Technical Letter Report on The General Electric PLEDGE Code for the Prediction of Environmentally Assisted Crack Growth Rates

Revised April 2, 2000

Prepared by
W. J. Shack

Program Manager
M. McNeil
USNRC Office of Nuclear Reactor Research

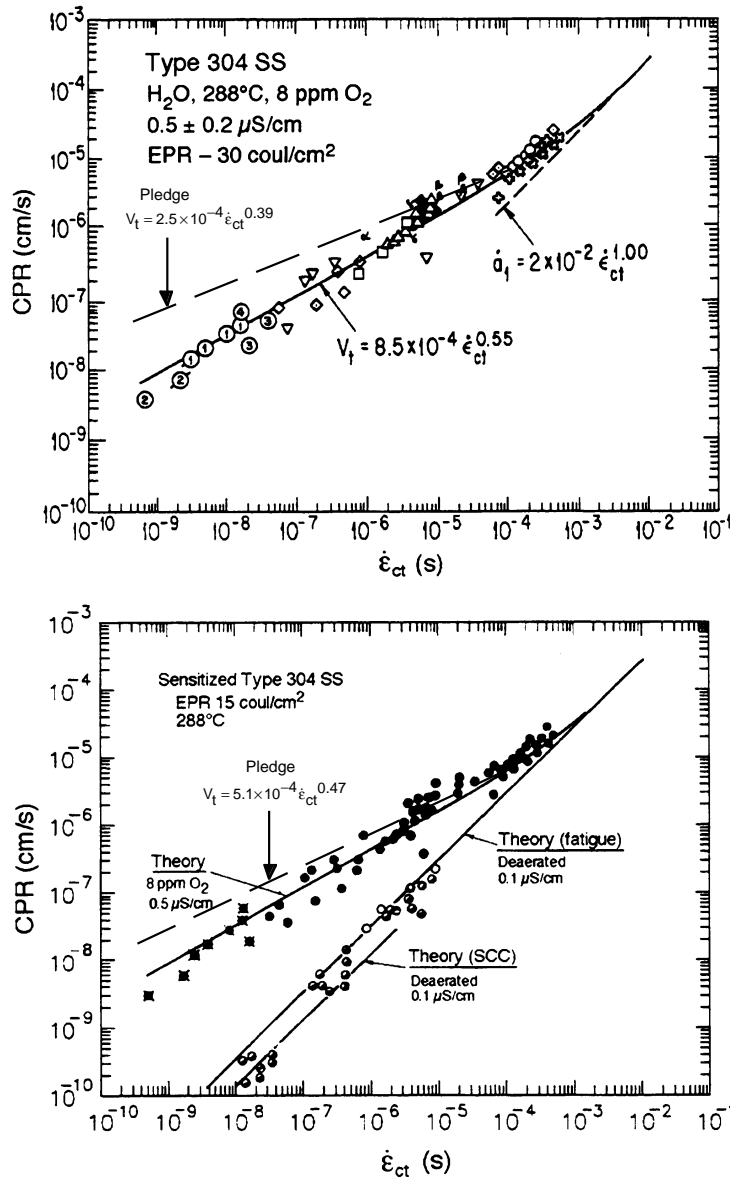
PLEDGE predictions have been compared with experimental results in many presentations and papers by GE. However, virtually all of these comparisons are presented in graphical terms without tabular data, and it is often difficult to determine the precise conditions of the comparison. See, for example, the comparisons shown in Fig. 1, which were taken from Ref. 1, but which have appeared in several other publications. The “Theory” referred to in the figures may be an earlier version of PLEDGE. The predictions of the version supplied to the NRC are

labeled “PLEDGE” and are significantly different from the theoretical results, which a reader would presumably assume to be based on PLEDGE. The actual experimental conditions are unclear. The high CGR data in (a) and (b) appear to be identical. In one case they are identified as $EPR=30\text{ C/cm}^2$ and in the other as $EPR=15\text{ C/cm}^2$. Additional examples of such confusion can be found in other comparisons of data with PLEDGE in various GE reports. Since the data are not presented in tabular form with a precise statement of the actual experiment conditions, it is difficult to make independent comparisons.

Figure 2. Comparison of CGRs predicted by PLEDGE with experimentally observed CGRs. The comparison is of little use in establishing the validity of PLEDGE because relatively few of the data are taken under conditions in which environmentally enhanced cracking is significant.

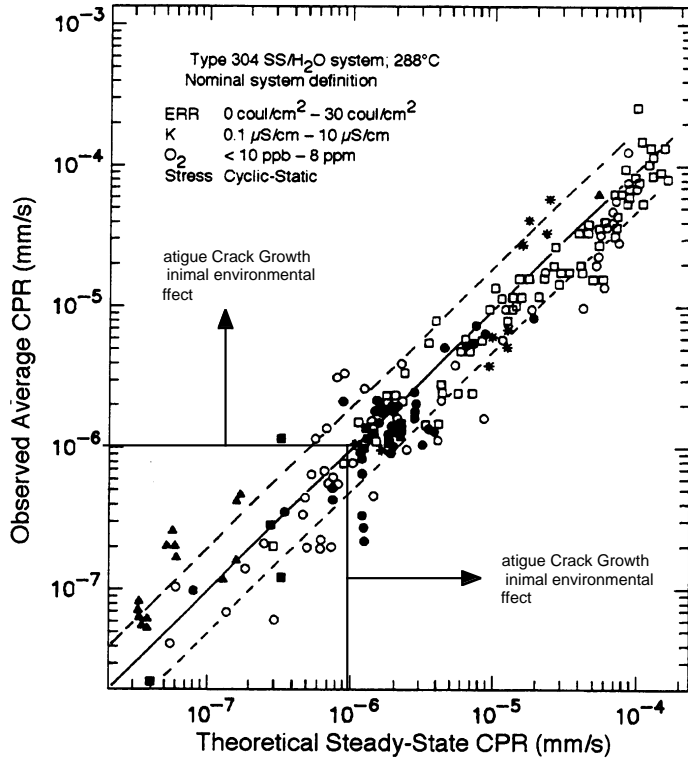
A comparison based on large set of data (340 pts) purportedly covering a wide range of environmental and material conditions is shown in Fig. 2. The figure was taken from Ref. 1, but also has appeared in many other papers. The only information available about the data is that shown in the graph. However, even if these data were to be documented, it is very unlikely that they would provide an adequate benchmark to demonstrate the adequacy of PLEDGE and estimate the uncertainties associated with PLEDGE predictions of SCC CGRs. Under typical BWR conditions, SCC CGRs are less than $3.5 \times 10^{-10}\text{ m/s}$ ($5 \times 10^{-5}\text{ in/h}$). This value has in fact been used as a conservative bound for NRC assessments. Only about 20 of the 340 data points in Fig. 2 appear to be obtained under conditions that give CGRs less than this value. There are about 20 more data with CGRs $<1 \times 10^{-9}\text{ m/s}$ where it could be argued that the environmentally induced cracking was at least some reasonable fraction of the mechanically driven CGR. The remaining ≈ 300 data points must have been obtained under cyclic loading conditions in which the scatter in the mechanically driven fatigue CGRs is at least as large as the environmentally induced CGRs (and for CGRs $>10^{-8}\text{ m/s}$ much larger). They are fatigue tests and would give similar results whether conducted in air or in water. Indeed PLEDGE itself predicts that under the cyclic loading conditions required to produce these high growth rates, there is little difference in the CGRs in air and in the environment.

Figure 4
Predicted effect of variation in EPR on CGR for constant loads at different ECP levels.

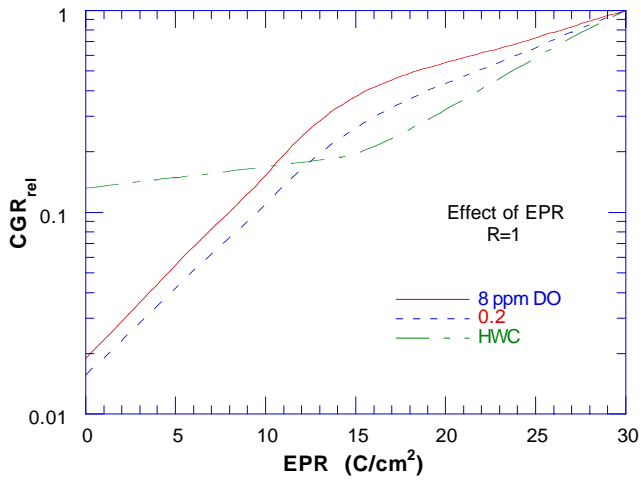
An important input to PLEDGE is the EPR (electropotentiokinetic reactivation), a measure of the degree of sensitization of the material. Variations in EPR value over the range of 0–30 C/cm² result a factor of ≈ 50 change in the crack growth rates predicted by PLEDGE as shown in Fig. 4 at high ECP. EPR provides a characterization of the grain boundary chromium level. Unfortunately the correlation between EPR and grain boundary chromium content is subject to significant uncertainty. Because EPR depends on both the width and the depth of the chromium depleted zone, the EPR value depends strongly on the overall thermal history and not just on the grain boundary chromium content. For example, low temperature aging tends to produce narrower depleted zones than high temperature aging treatments, so that an EPR value for a low temperature aged material corresponds to a lower grain boundary chromium concentration than that corresponding to the same EPR value for a high temperature aged material. The calculations with PLEDGE used reported values of the EPR except for ANL data which used a two step sensitization process involving a low temperature aging step. In this case the value reported by ANL was 2 C/cm². Because this would underestimate the EPR value that be be observed for the same grain boundary chromium level in a material with a high temperature treatment a value of 15 C/cm² was initially assumed in

the calculations. Since EPR as used in PLEDGE is not truly a measured quantity (it really reflects the analysts judgment as to the degree of chromium depletion at the grain boundary), the strong dependence on EPR makes it a potent “adjustable” parameter. Post-hoc adjustments of the EPR value would permit PLEDGE predictions to be “tuned” to experimental data.

Figure 5.
(a) Comparison of the predictions of the PLEDGE model with the Andresen data set; (b) Comparison of the predictions of the PLEDGE model with the ANL IGSCC data set; (c) Comparison of the predictions of the PLEDGE model with the BWRVIP data set

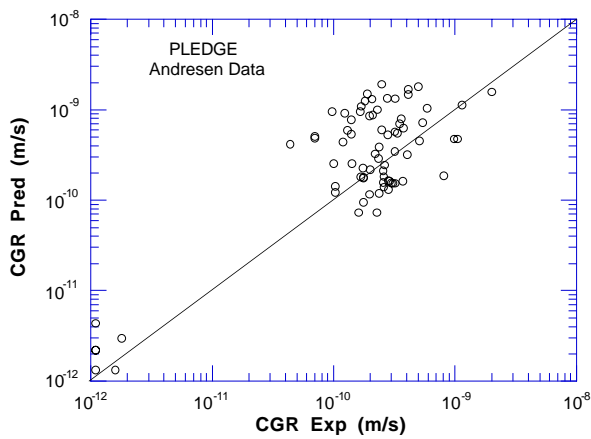
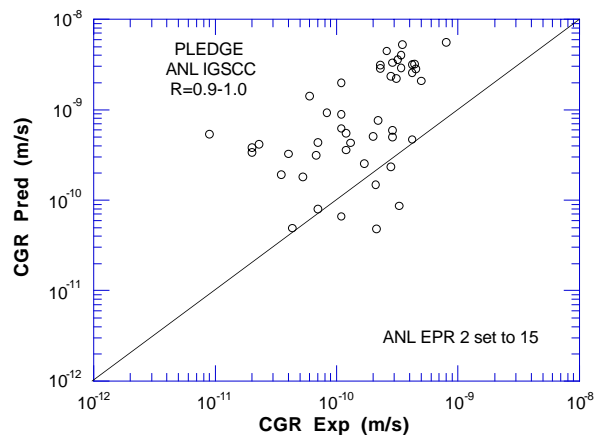
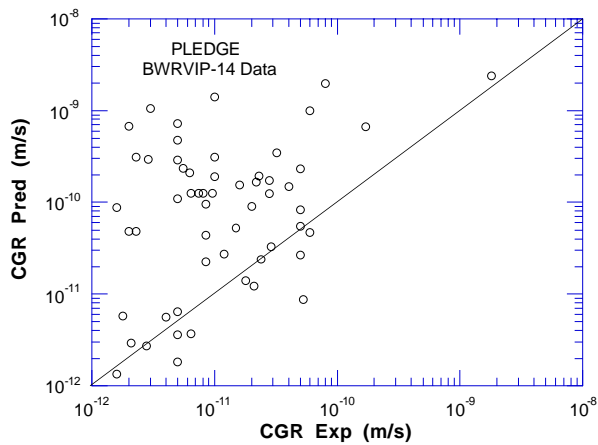
The PLEDGE predictions are compared with the Andresen, ANL IGSCC, and BWRVIP data bases in Fig. 5. Although there is considerable scatter in the results, in almost all cases the PLEDGE prediction is conservative. PLEDGE predictions are compared with ANL TGSCC in Fig. 6. In this case the appropriate EPR value is 0; and there is no particular bias to the predictions. The number of conservative predictions are about the same as the number of nonconservative predictions.

PLEDGE appears to provide conservative predictions of crack growth rates in sensitized materials provided that an appropriate value is used for EPR. For applications to weldments a value of 15 C/cm² would appear appropriate and yields a moderate degree of conservatism. For environmentally assisted fatigue for which the growth is expected to be transgranular, the choice of EPR = 0 gives reasonable values for the mean behavior, but does not bound much of the data. Some additional margin appears appropriate. This could again be provided by assuming EPR = 15 C/cm².

Figure 10. (a) Comparison of the predictions of the PLEDGE model with ANL high DO data, data from Kawakubo et al.¹¹ and data used to develop the NRC Disposition curve; (b) Comparison of predictions of the BWRVIP 95 model modified to account for cyclic loading with the same data.

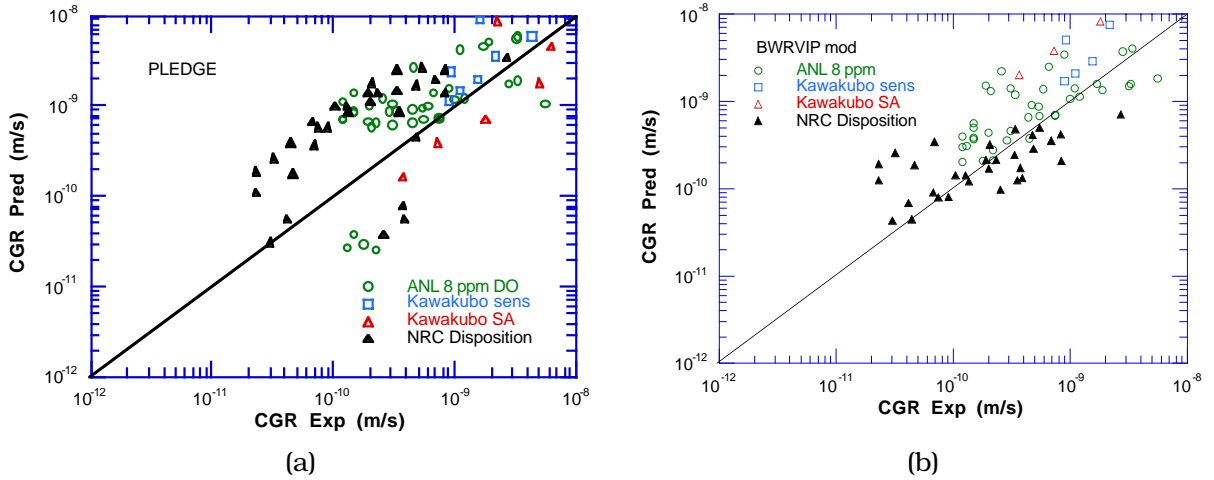
The predictions of the models with data for high dissolved oxygen levels from ANL and Refs. 11 and 12 are shown in Figs. 10. Both the PLEDGE and BWRVIP models are conservative in most cases. In Fig. 11 comparisons are shown with cyclic CGR data from ANL and Refs. 13-18. With an EPR value of 15 C/cm² the PLEDGE predictions are conservative for both sensitized and nonsensitized materials. When the EPR value is set to 0 as would be appropriate for nonsensitized materials, the results are no longer necessarily conservative.

Figure 17 (a) Effect of sensitization on CGR observed in cyclic load tests of Kawakubo et al.¹¹ (b) PLEDGE prediction of change in CGR due to change in sensitization.

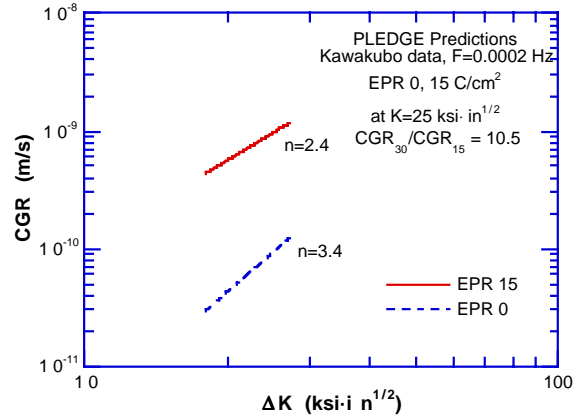
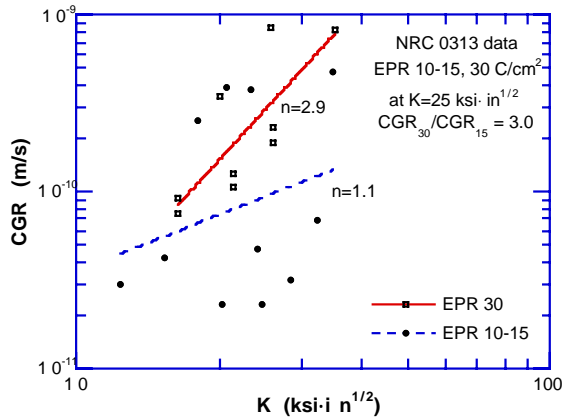
Data from other sources were also examined to try to determine dependence on conductivity, sensitization, and ECP. The data of Kawakubo et al.¹¹ comparing crack growth rates in materials with EPR = 0 and 15 C/cm² are shown in Fig. 17(a) along with the corresponding PLEDGE predictions in Fig. 17(b). The prediction is about 3 times as that observed at a stress intensity of $K = 27 \text{ MPa}\cdot\text{m}^{1/2}$. Data with EPR of 10–15 and 30 C/cm² used to develop the NRC disposition curve¹² are shown in Fig. 18(a) along with the corresponding PLEDGE predictions in Fig. 18(b). There is large scatter in the data, but nominally the difference is again about a factor of 3 at a stress intensity of $K = 27 \text{ MPa}\cdot\text{m}^{1/2}$. These results are consistent with the results determined from the BWRVIP data as shown in Table 4.

Part of the reason PLEDGE may overestimate the effect of sensitization may be in the experimental models it uses to represent the material at the crack tip. In solution-annealed material the crack tip is Fe18Cr8Ni, in weld-sensitized material it is Fe8Cr10Ni, and in furnace-sensitized material it is pure Fe.² The actual relation between the oxidation current densities measured on these materials and the dependency on EPR built into PLEDGE is part of the proprietary “black box”, but it certainly is conceivable that such assumptions would result in an over estimate of the effect of sensitization.

Figure 19 Predicted effect of variation in conductivity on CGR for R=0.95 loading. Data shown are from a controlled test where conductivity was varied keeping all other variables constant

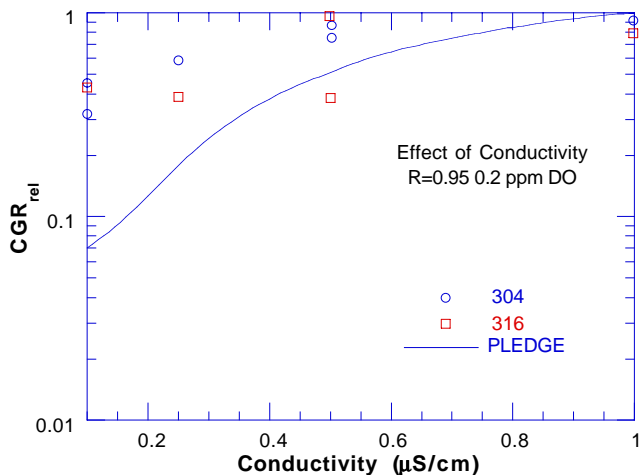
As noted from the examination of the databases, PLEDGE appears to predict a stronger dependence on conductivity than is observed. This is consistent with the results from a “controlled” experiment in which conductivity was systematically varied while keeping all other experimental parameters constant shown in Fig. 19. In application to operating reactors, the conductivity as defined by PLEDGE should be a conservative representation of the impurity effects. “Conductivity” is really used as a surrogate measure for harmful anions such as SO_4^{2-} and Cl^- ; other anions may be much more benign. PLEDGE assumes that the conductivity is due to the “worst-case” impurity, sulfate.

Figure 21
Dependence on crack tip strain exponent n on corrosion potential and bulk solution conductivity for a sensitized SS. The slope n decreases as the conductivity increases at any fixed potential. From Ref. 1.

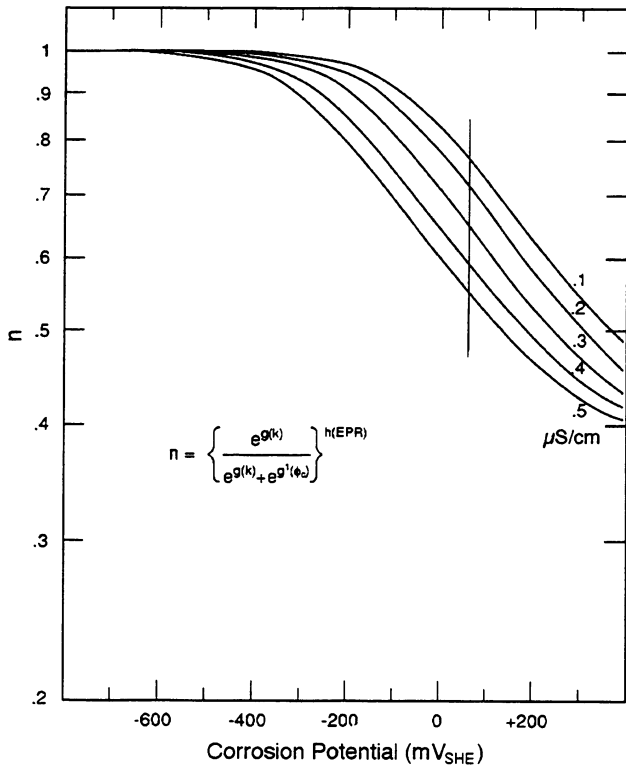
Only a small sample of the experimental data upon which the dependencies on critical variables included in PLEDGE were constructed is available for review even in restricted distribution documents such as EPRI NP-5064s.² However, the limited data available on the effect of conductivity seems somewhat contradictory to the dependency on conductivity in PLEDGE. In Fig. 20, the effect of sulfate concentration on oxidation current density transient after a potential pulse to -420 mV in pH₂₅ 2.0 solution is shown. The slope of the current transient clearly increases as the concentration is increased. In Fig. 21, the dependence on crack tip strain exponent n on corrosion potential and bulk solution conductivity for a sensitized SS, which is equal to the slope observed for oxidation current density is shown. The slope n decreases as the conductivity increases at any fixed potential, which seems to contradict the result shown in Fig. 20.

Figure 22 Predicted effect of variation in ECP on CGR for $R=0.95$ loading. Data shown are from a controlled test where ECP was varied keeping all other variables constant.

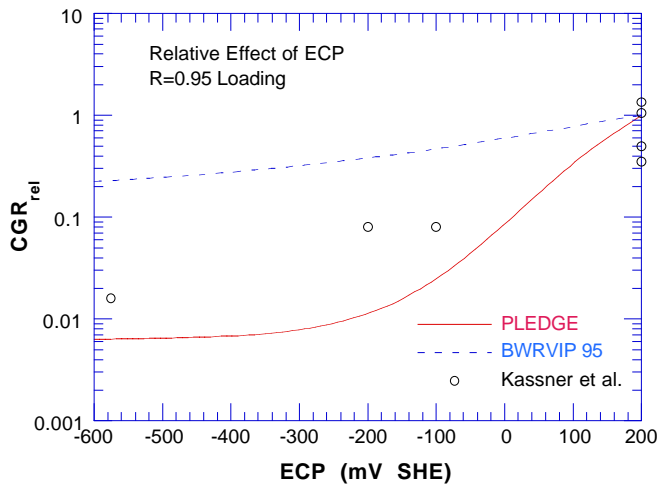
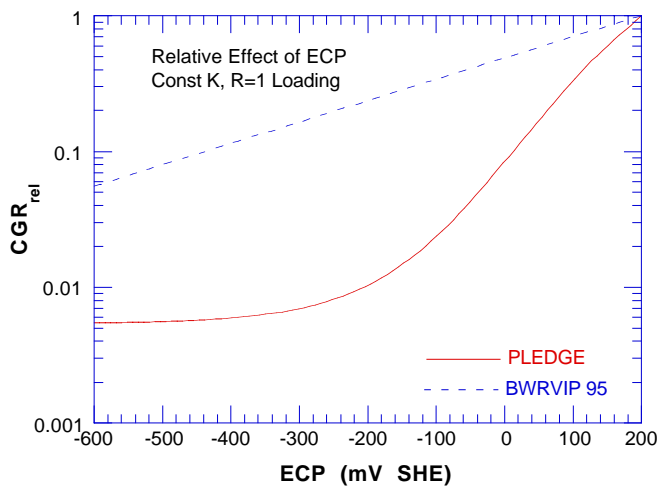
The predicted dependence of CGR on ECP is shown in Figs. 22 and 23. In this case the dependency is quite sensitive to the loading condition. Under $R=1$ loading the CGR essentially vanishes; under the $R=0.95$ loading, the mechanically driven CGR places a floor on how low the rate can go and so the relative change is smaller. The reductions predicted by PLEDGE are hard to verify experimentally, because the CGRs so low that they are extremely difficult to measure. The much more modest reductions predicted by the BWRVIP model are probably skewed by unavailability and scatter in CGRs at such low levels. Many of the ANL tests in hydrogen water chemistries are not reported as CGRs, simply because they were so low that it would take an inordinate amount of time to obtain a valid CGR. However, Ruther and Kassner carried out a series of tests on a thermally aged cast SS,²³ which showed a high susceptibility to environmentally assisted cracking, in which the tests were continued until the CGRs could be measured with some confidence. Their measurements are also shown in Fig. 22. They suggest that the BWRVIP model is very conservative at low ECPs, but that the PLEDGE model predicts the overall trends reasonably well. These results together with the results in Table 5 suggest that the PLEDGE model predicts the variation of the CGR with ECP fairly well overall, although it may overestimate somewhat the increases in CGR associated with increase in ECP above 140 mV.
